Re: Watson Cogeneration Steam and Electric Reliability Project
Application for Certification 09-AFC-1

RESPONSES TO QUESTIONS FROM THE JANUARY 20, 2010 ISSUES RESOLUTION WORKSHOP for Watson Cogeneration Steam and Electric Reliability Project

Technical Area: Soil and Water Resources

| WATER BALANCE FLOW DIAGRAM FIGURE 5.5-1 | | | | | |

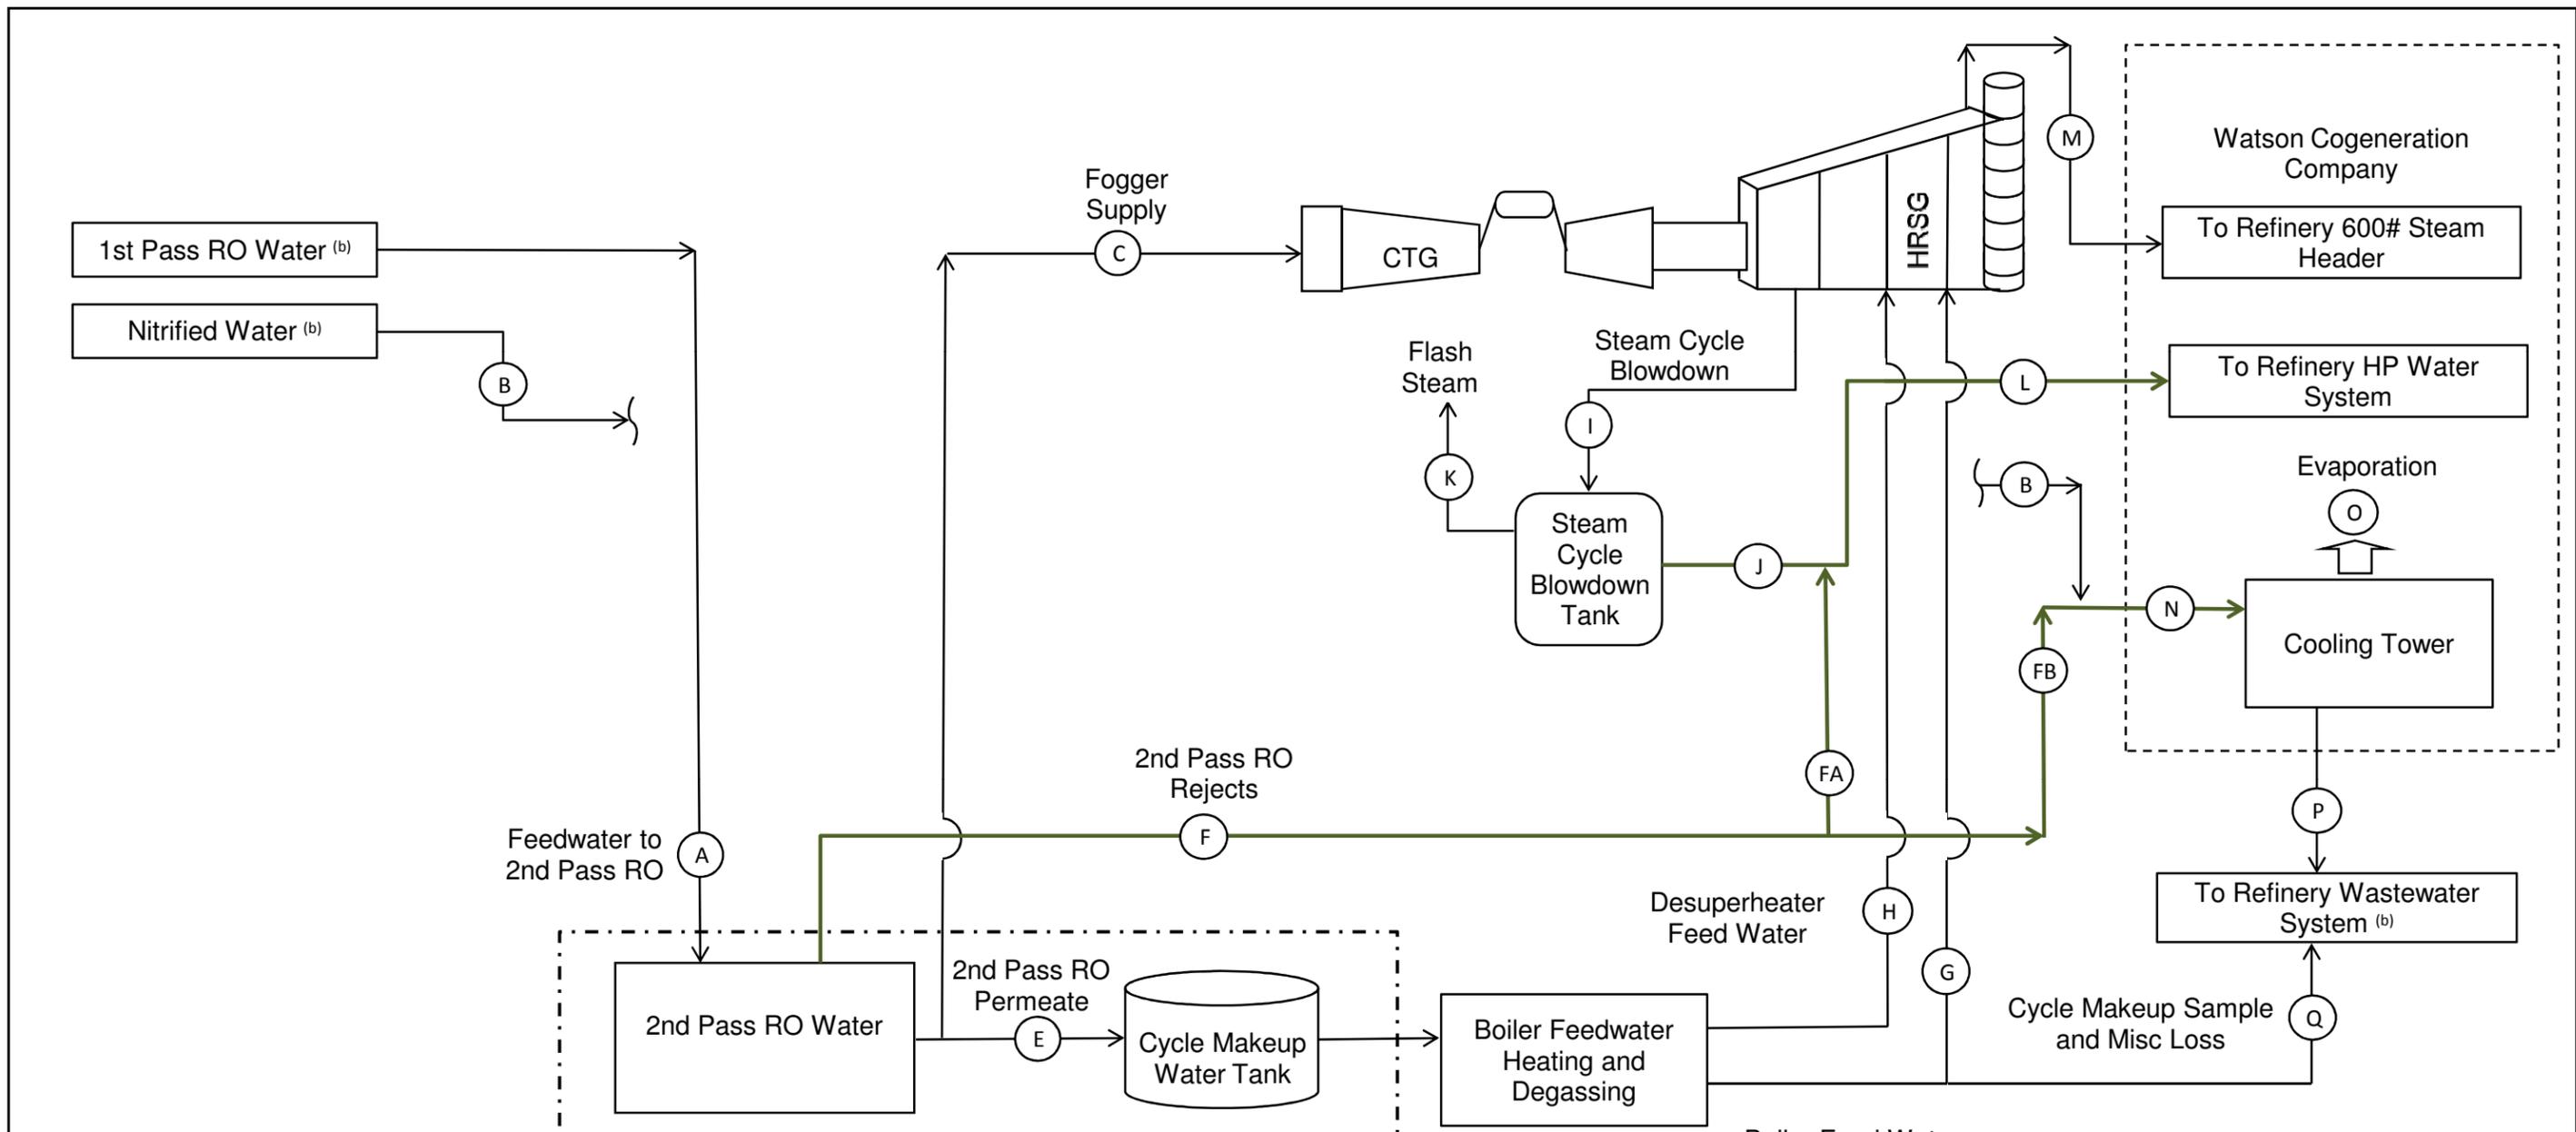
- 2. Please propose a Condition of Certification to monitor the water exiting the Project and to provide a minimum percentage of water to the BP Refinery based on the total water coming into the Project*

Watson proposes the following language for the requested condition of certification: Prior to commercial operation, the Project owner shall install and maintain metering devices as part of the Project water supply and distribution system, to monitor and record in gallons per month the total volumes of water supplied to the Project via lines C, E, and F of the attached AFC Figure 5.5-1, Water Balance Flow Diagram, and the volumes of water supplied by the Fifth Train to Watson Cogeneration Company's steam header via line M and high-pressure water system via line L. The metering devices shall be operational for the life of the Project. On an annual basis, no less than 82 percent of the total volume of water supplied to the Fifth Train shall be delivered to the Watson Cogeneration Company's steam header and/or high-pressure water system.

Verification: At least 30 days prior to commercial operation of the Project, the Project owner shall submit documentation to the California Energy Commission (CEC) Compliance Project Manager (CPM) that metering devices for the Project have been installed on lines C, E, F, L, and M and are operational. The Project owner shall prepare an annual water usage summary giving the monthly total and annual total of water delivered to the Fifth Train via lines C, E, F, and from the Fifth Train to the Watson Cogeneration Company's steam header and/or high-pressure water system. The summary shall also state the annual percentage of the volume of water supplied to the Fifth Train that is delivered to the Watson Cogeneration Company's steam header and/or high-pressure water system. The percentage shall be computed as $(L+M)/(C+E+F)$. The annual summary shall be included in the Annual Compliance Report.
